IEEE P802.3at Task Force Power Via MDI Enhancements

Suggested Remedy for Voffset and Ioffset comments September 2008

Yair Darshan / Microsemi Corporation

Figure TBD: Voffset and Ioffset definitions

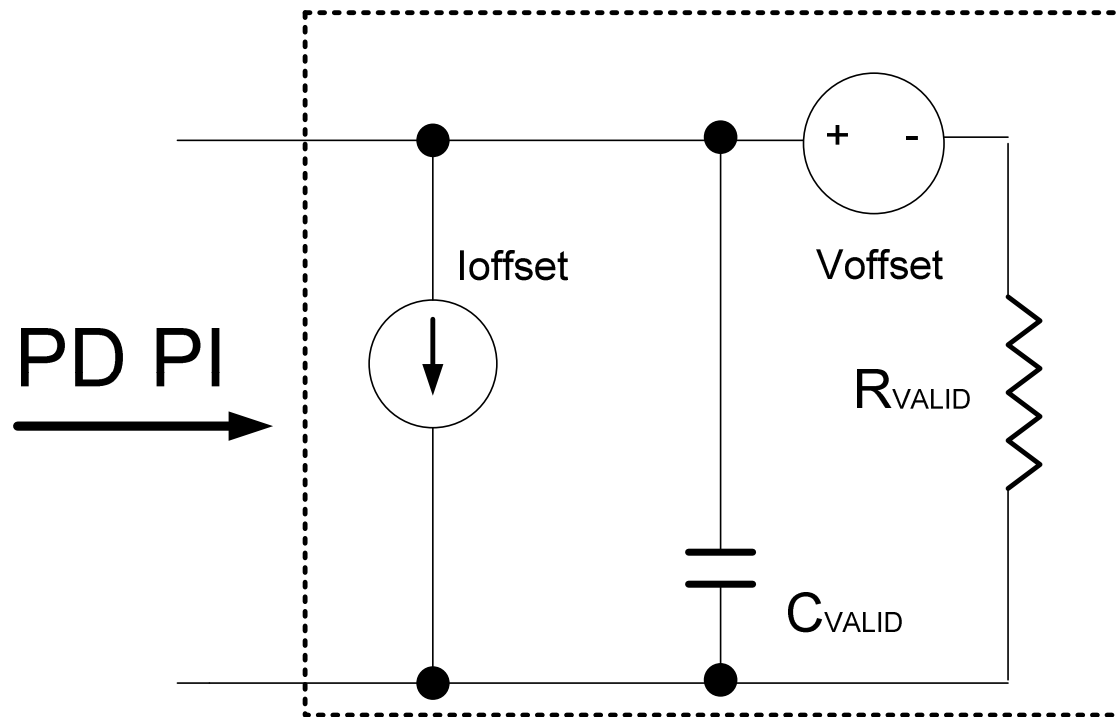
- While Voffset definition is clear from this drawing, Ioffset is not clearly defined.
 - Meanwhile the whole annex was deleted in Draft D3.1 and the question is even more valid: What are the definitions for Voffset and Ioffset and how to test them?

- To use the following model to define Voffset and Ioffset. This model was taken from the informative section of IEEE802.3AF - 2005

- 1. Add Figure TBD after Table 33-15 in 33.3.4
- 2. Add revised figure 33C.20 after figure TBD in 33.3.4
- 3. Add additional information column for Table 33-15 for items 2 and 3 and add to it the following text: “See Figure TBD and Figure 33C.20 for Voffset and Ioffset definitions”
- 4. In Table 33-5 in the additional information for items 3 and 4:
 - Delete the current text regarding ANNEX 33A
 - Replace With: “See Figure TBD and Figure 33C.20 for Vos and Ios (Voffset and Ioffset at the PD) definitions”

Updated Figure 33C.20 for the normative section.

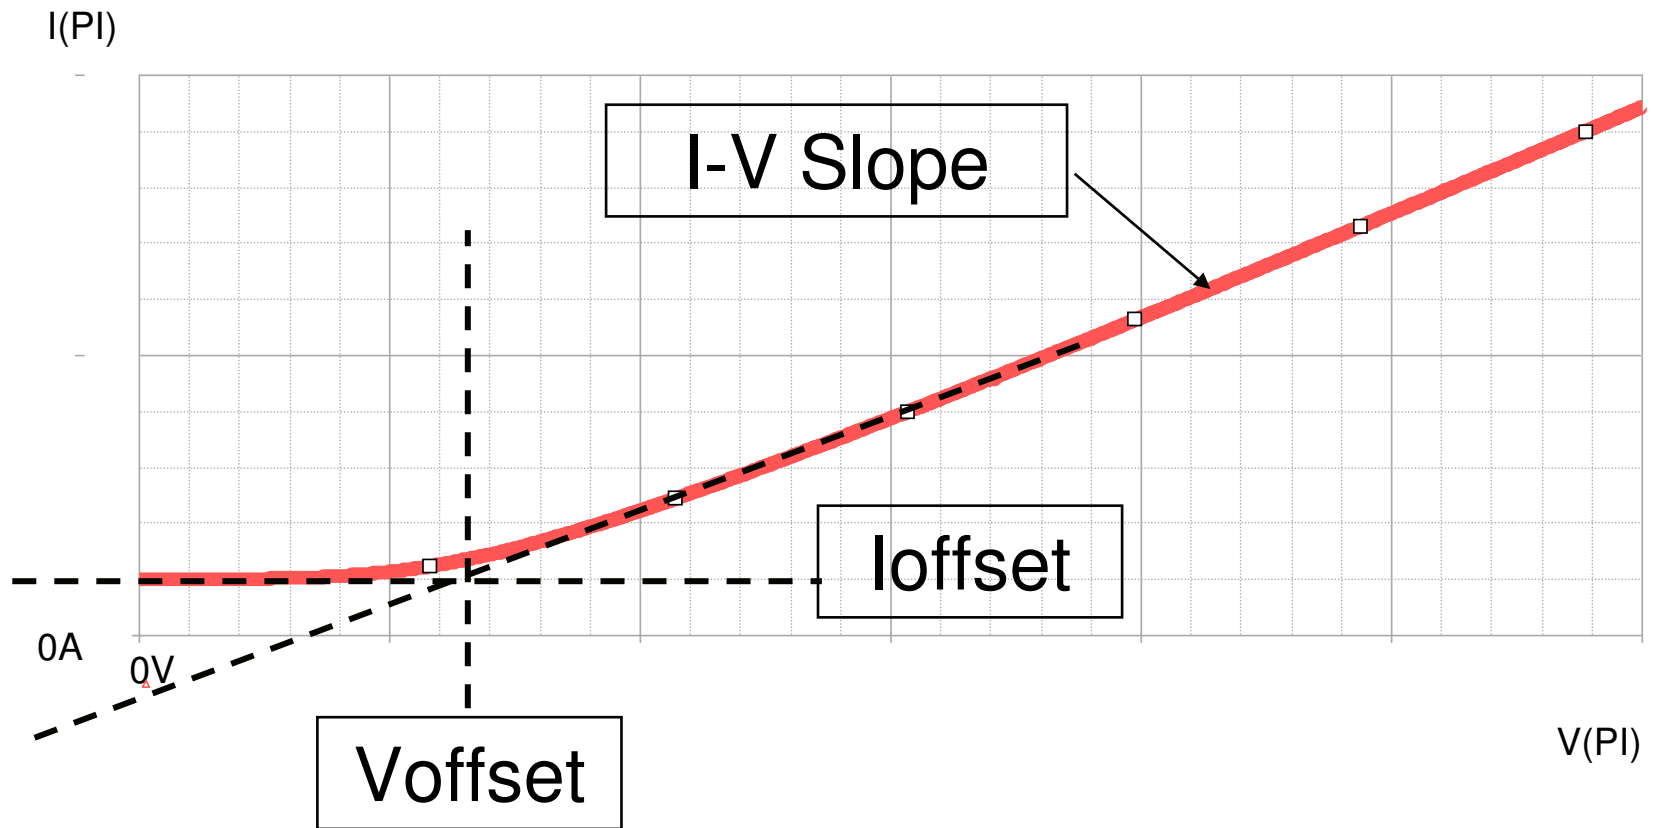
- Figure 33C-20 Signature voltage offset in the informative section of Draft D3.0 or 802.3af – 2005: **Voffset is the voltage when the PI current starts to increase above its previous steady state condition.**
